# CLUB RACING BOARD

## CLUB RACING BOARD MINUTES | May 3, 2016

# CLUB RACING TECHNICAL BULLETIN

NUMBER: TB 16-06

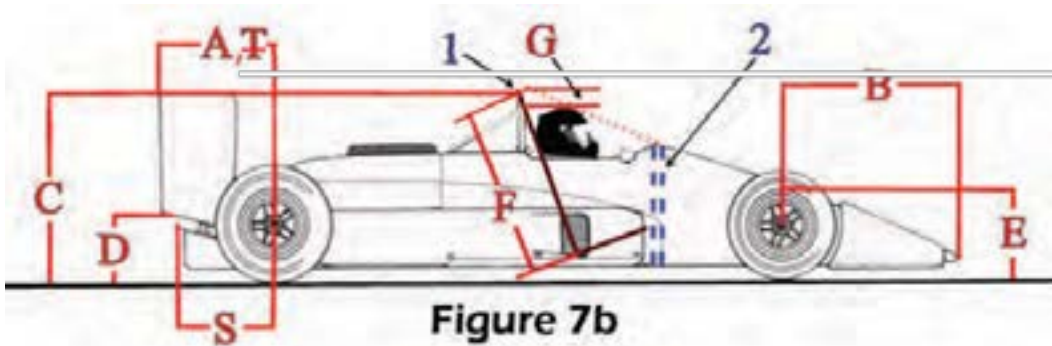
1. #18631 (James Blackwell) GCR Corrections  
 In F1000 (FB), figure 7a, make the following corrections:  
 Replace the dimension "R" in both locations with the letter "J"

In F1000 (FB), figure 7b, make the following correction:  
Delete the letter "T"
